JOSEPH M. FARLEY NUCLEAR PLANT, UNIT 1

AMENDMENT TO FACILITY OPERATING LICENSE

Amendment No.128  
License No. NPF-2

ATTACHMENT TO LICENSE AMENDMENT NO. 128

FIGURE 3.4-1

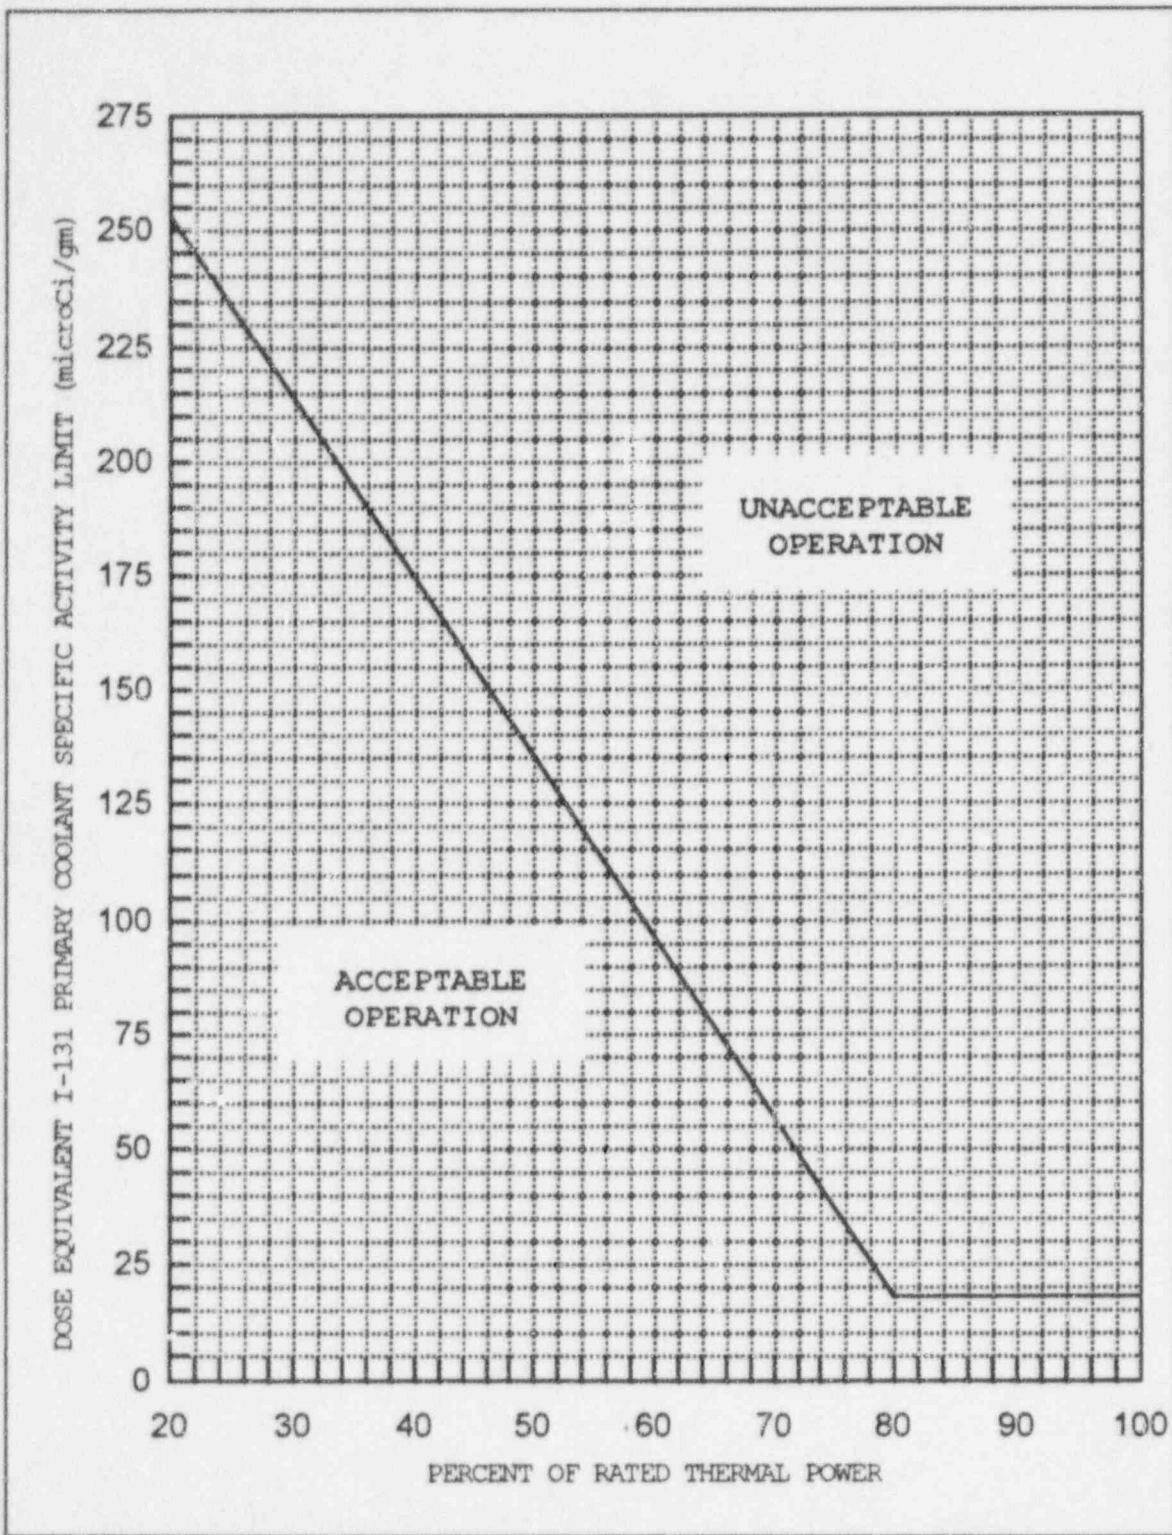
- a. With the specific activity of the primary coolant greater than 0.3 microCurie per gram DOSE EQUIVALENT I-131 for more than 48 hours during one continuous time interval or exceeding the limit line shown on Figure 3.4-1, be in at least HOT STANDBY with  $T_{avg}$  less than 500°F within 6 hours.
- b. With the specific activity of the primary coolant greater than  $100/\bar{E}$  microCurie per gram, be in at least HOT STANDBY with  $T_{avg}$  less than 500°F within 6 hours.

The ACTION statement permitting POWER OPERATION to continue for limited time periods with the primary coolant's specific activity greater than 0.3 microCuries/gram DOSE EQUIVALENT I-131, but within the allowable limit shown on Figure 3.4-1, accommodates possible iodine spiking phenomenon which may occur following changes in THERMAL POWER.
